Addendum (ADD) #01

| Project: | 20-602: Marshfield Early Childhood Center |
| Client: | Marshfield R-I School District |
| Date: | June 15, 2021 |

Go-1 MARSHFIELD EARLY CHILDHOOD CENTER
 AREA A CODE PLAN
 PROJECT NUMBER: 20-602
 DATE: 2021.06.09

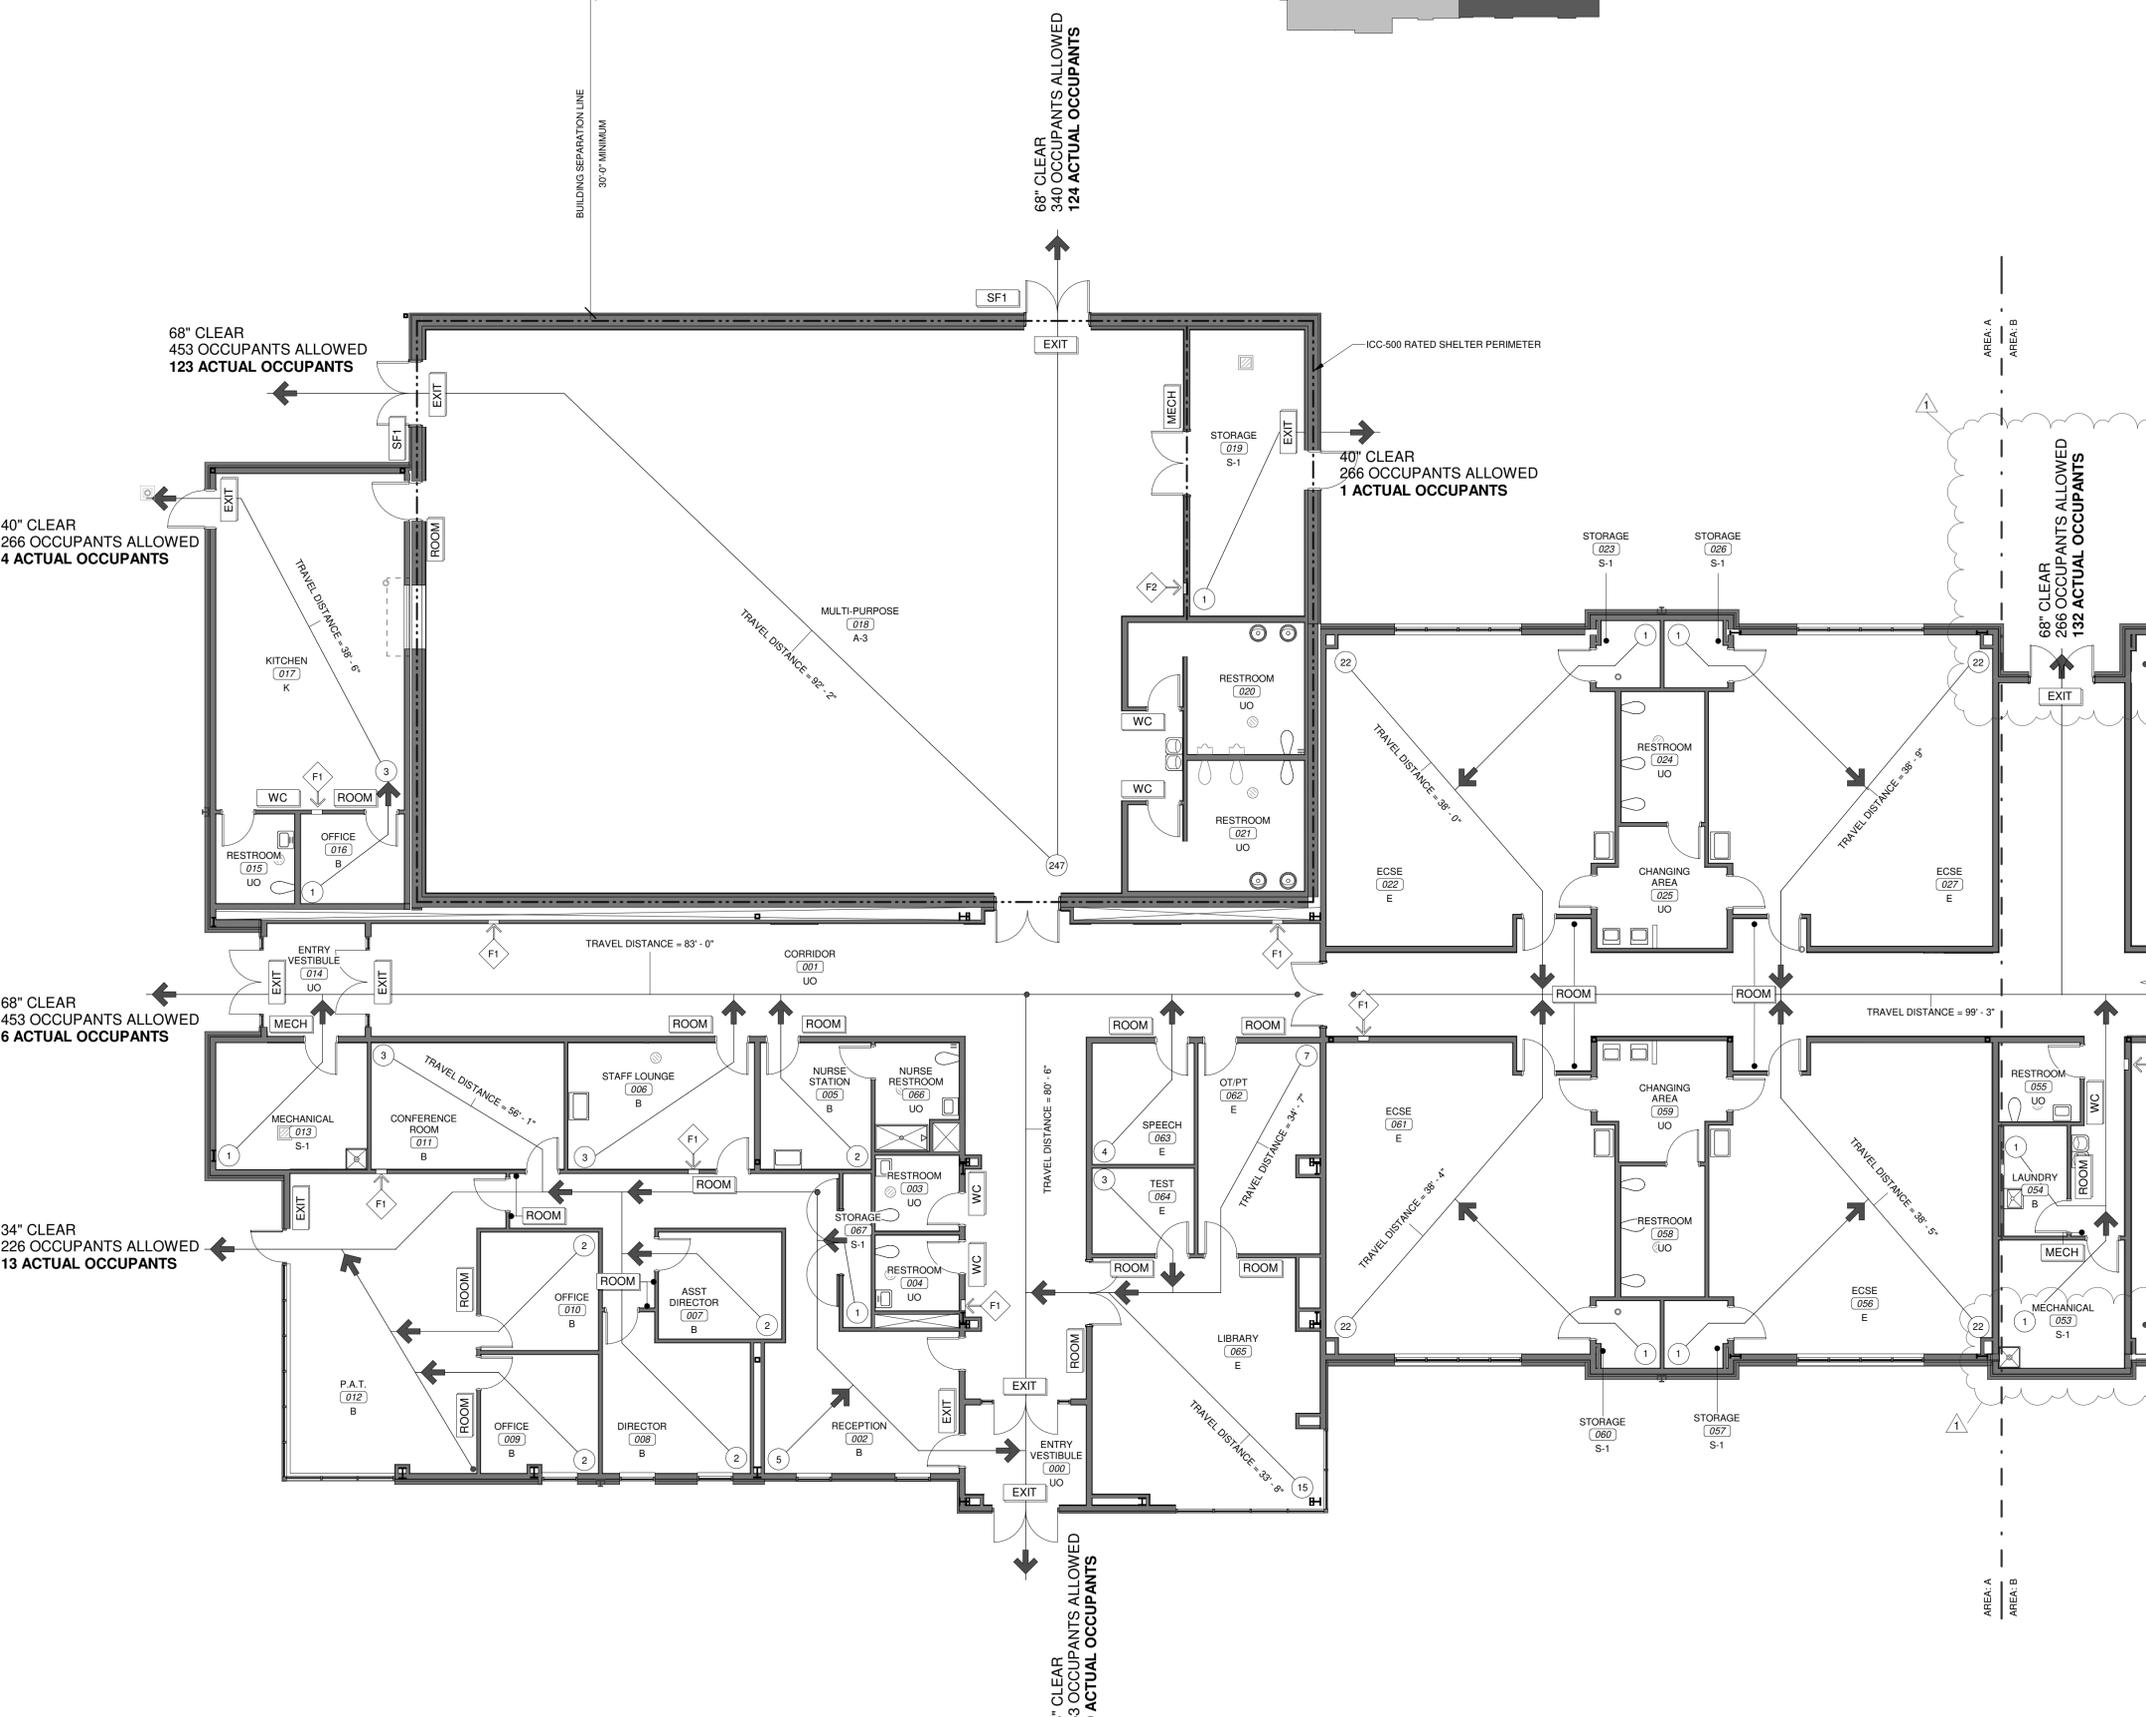
1. *Sheet G0-1 – Area A Code Plan:*
 - a. Revise, Detail 1
 - i. Building footprint adjustments at Corridor 028 and Mechanical 053.
2. *Sheet G0-2 – Area B Code Plan:*

G0-2 MARSHFIELD EARLY CHILDHOOD CENTER
 AREA B CODE PLAN
 PROJECT NUMBER: 20-602
 DATE: 2021.06.09

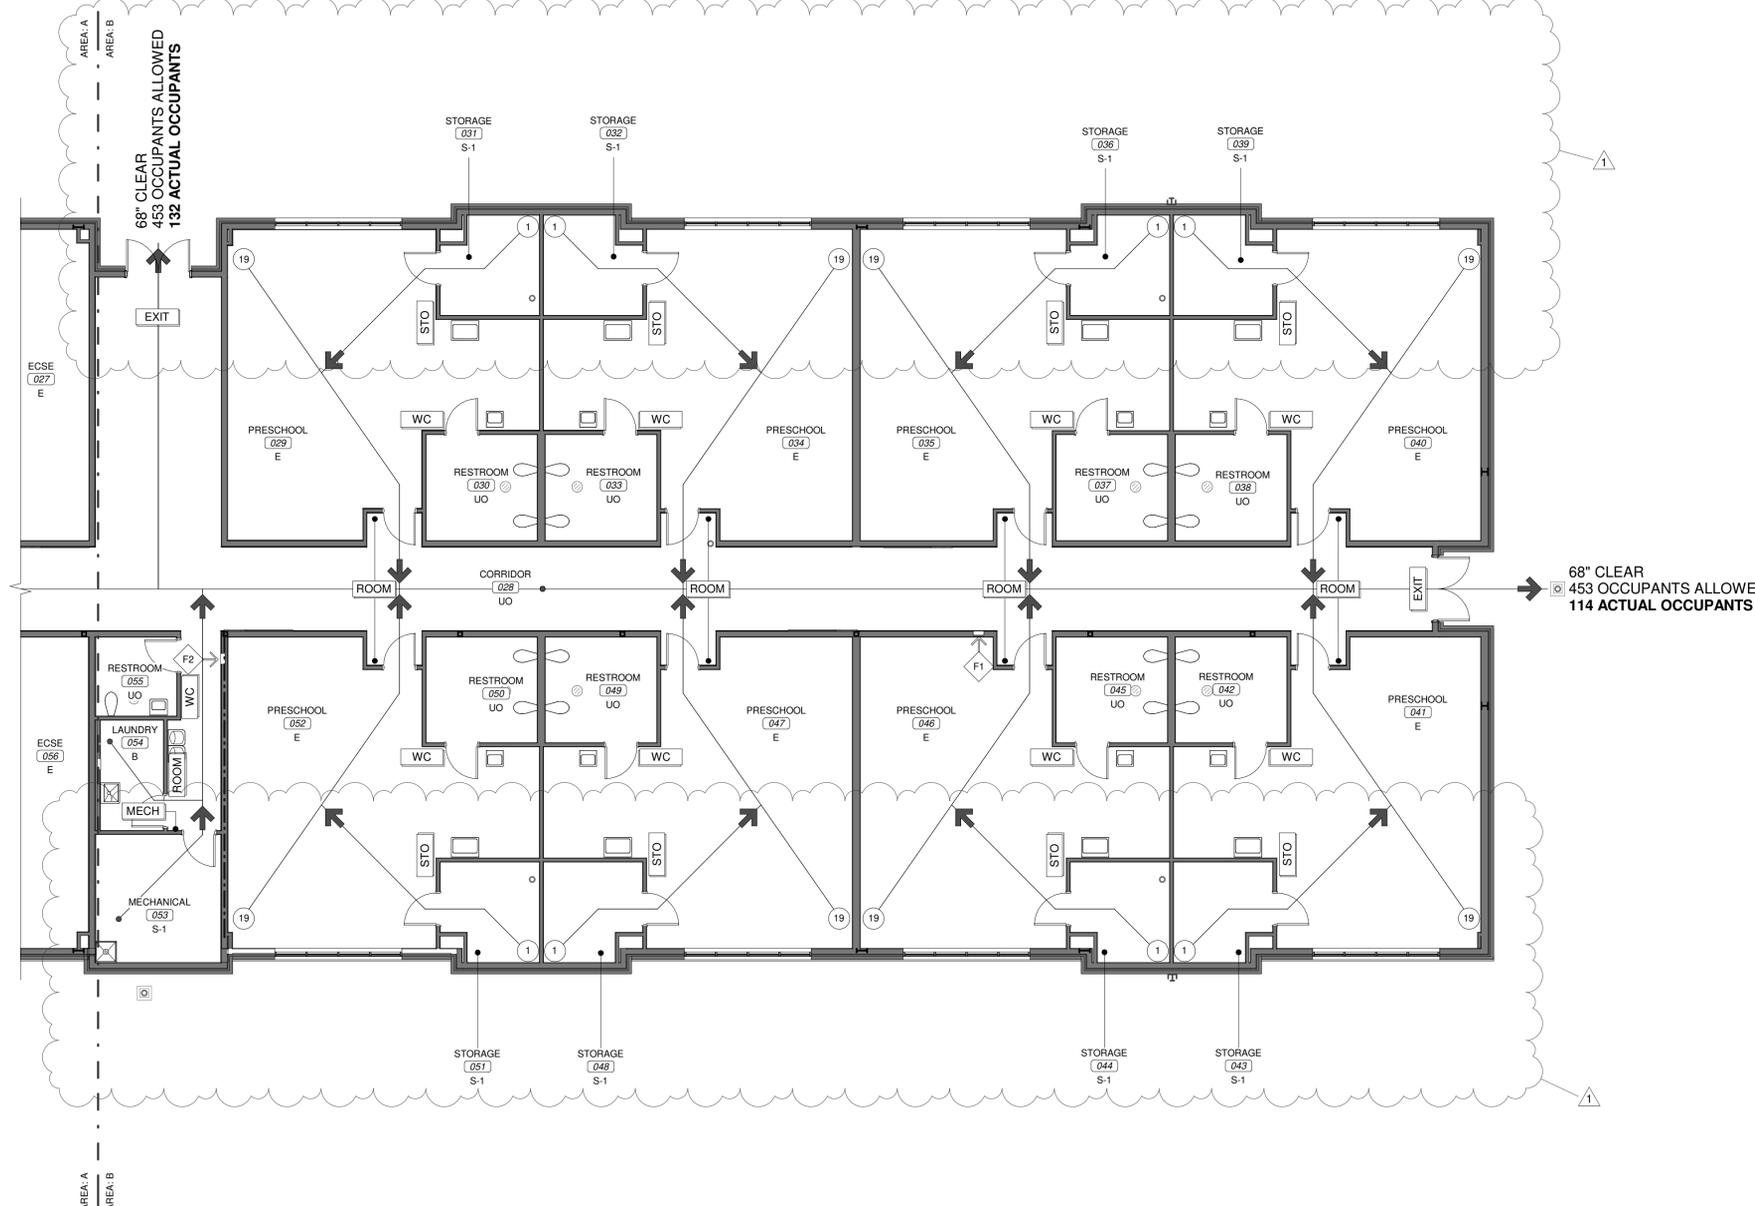
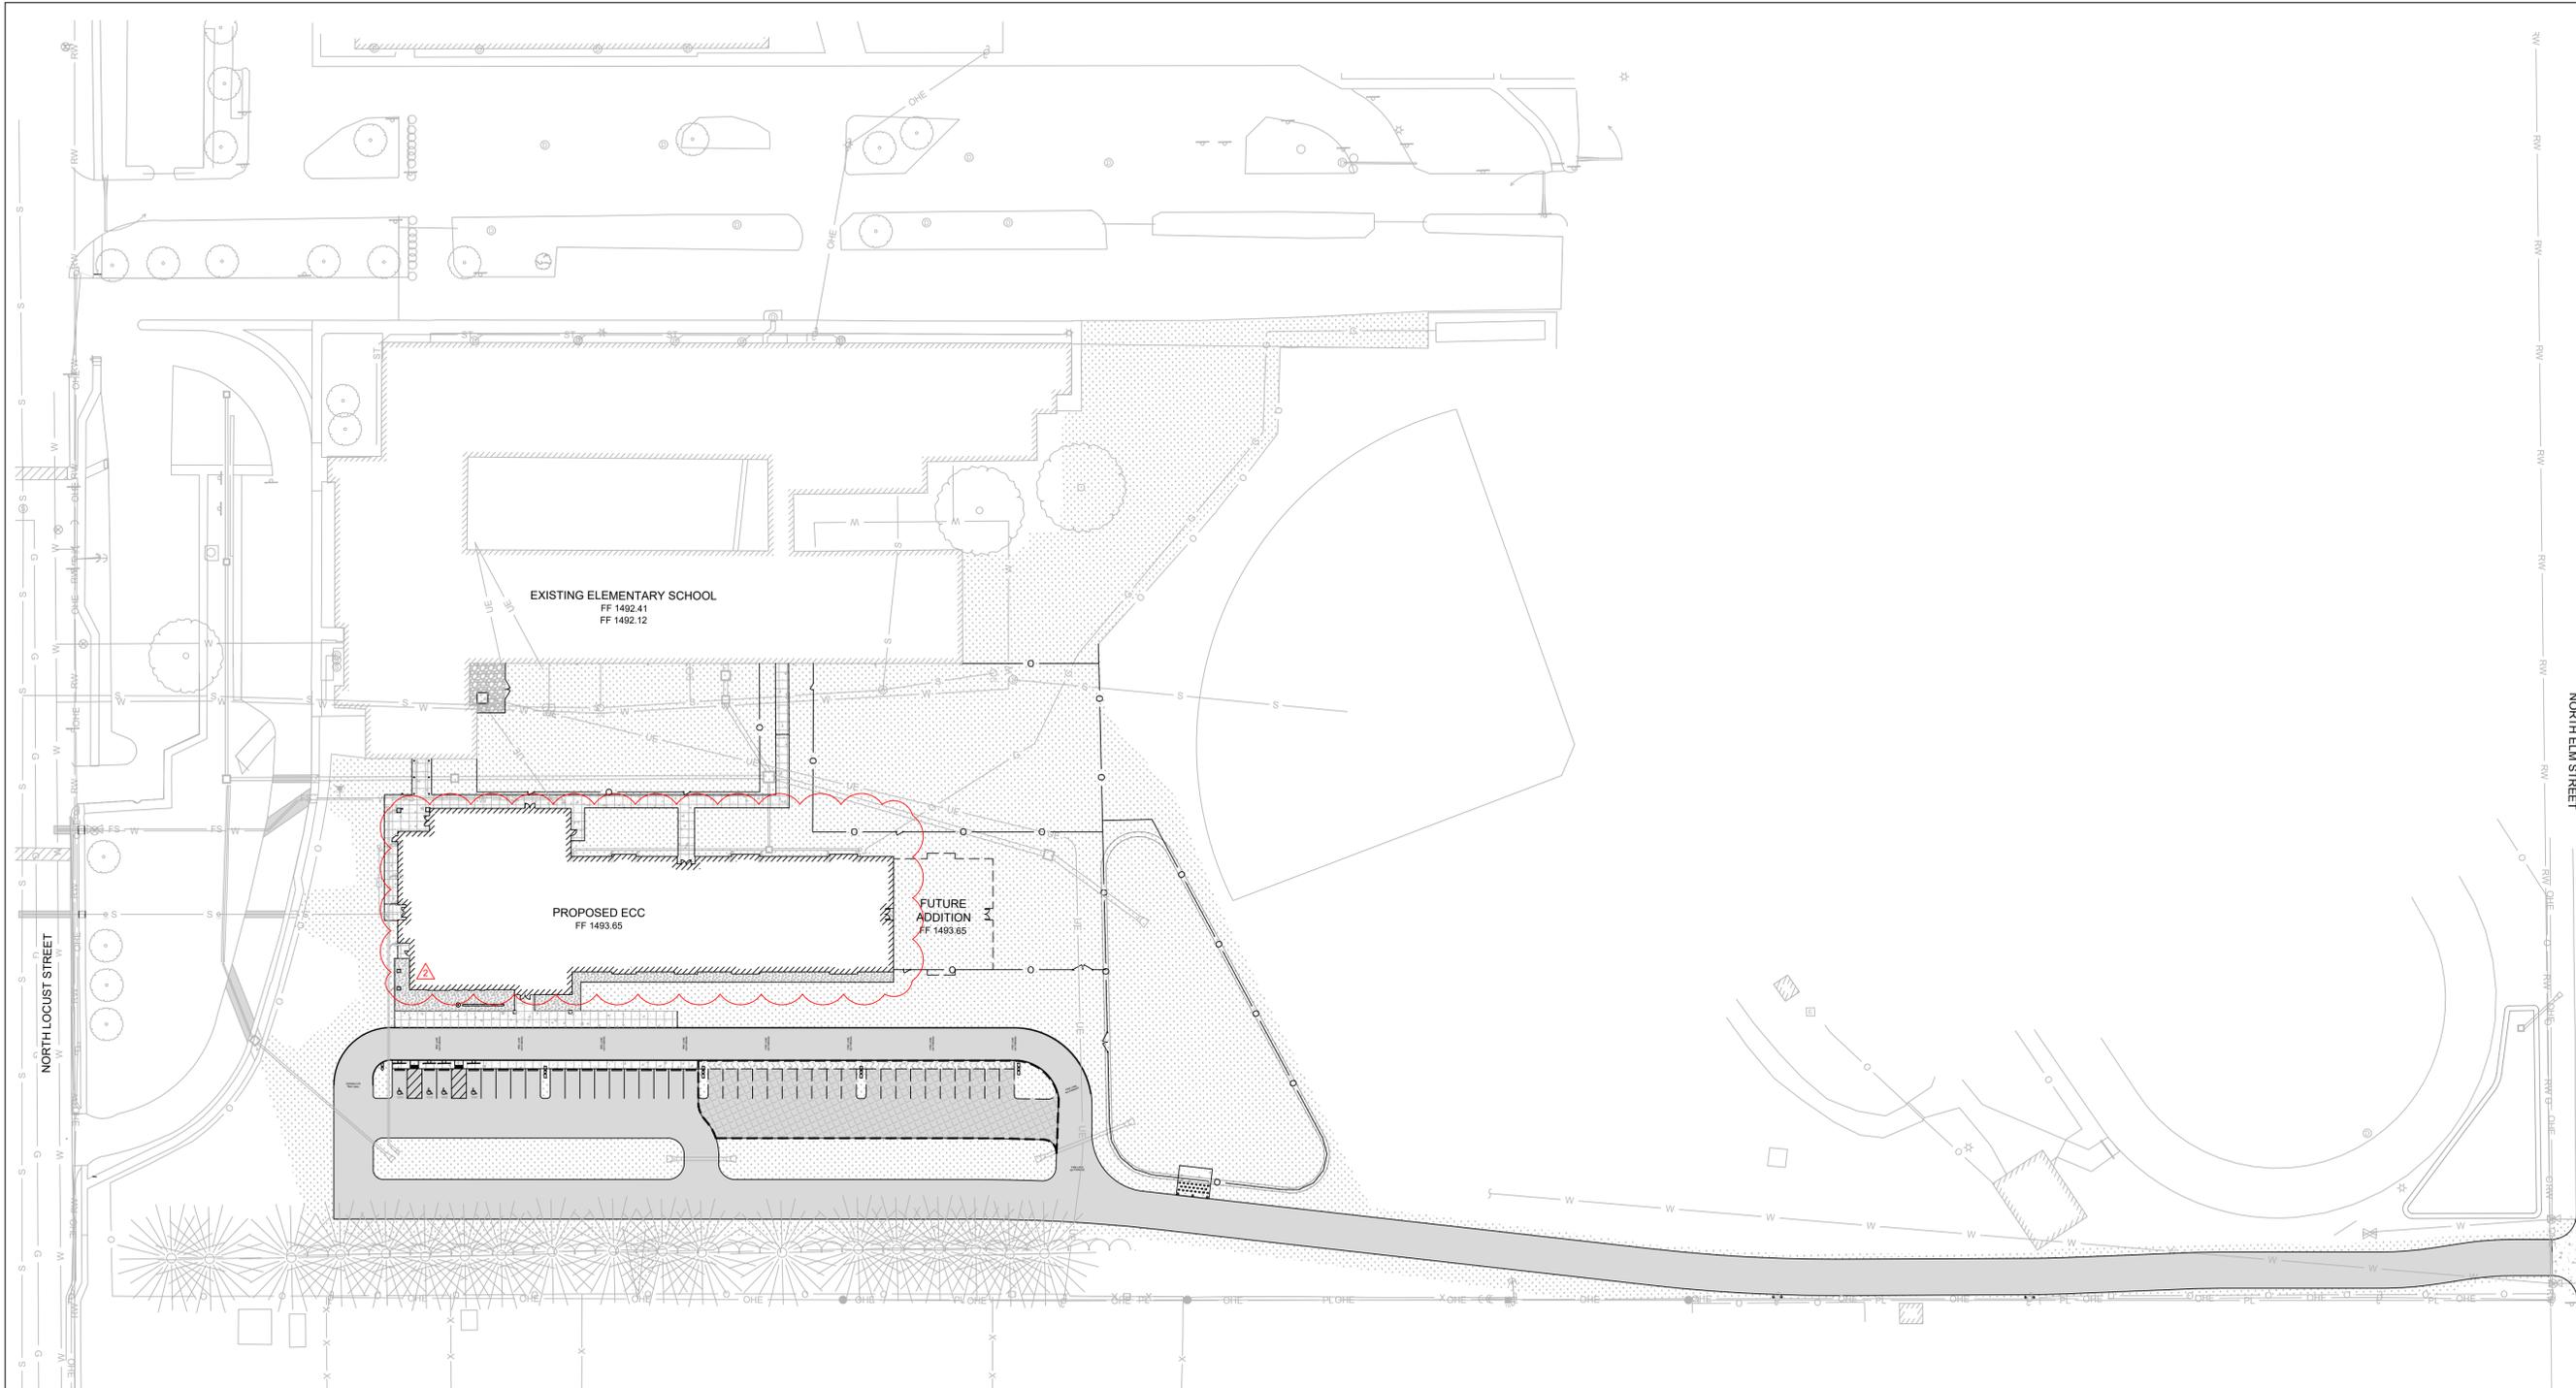
- a. Revise, Detail 1
 - i. Building footprint adjustments at north exterior walls and south exterior walls.
3. *Sheet A1-0 – Floor Plan - Area A:*
 - a. Revise, Detail 1
